**Subject: Annual Inspection Report
Lanett Municipal Airport**

ANNUAL INSPECTION REPORT

LANETT MUNICIPAL AIRPORT
LANETT, ALABAMA

INSPECTION SUMMARY

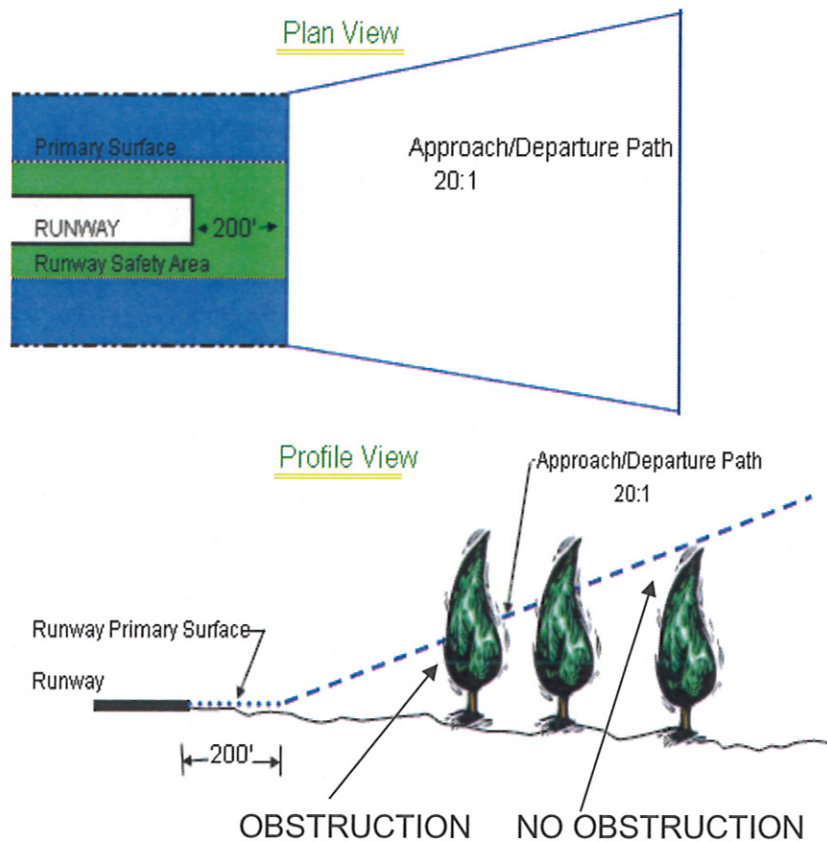
Inspection Area	Violation/Maintenance	Corrective Action
Wind Direction Indicator	Maintenance	Install properly fitting wind cone fabric
Airport Lighting	Maintenance	Replace/repair inoperative lights
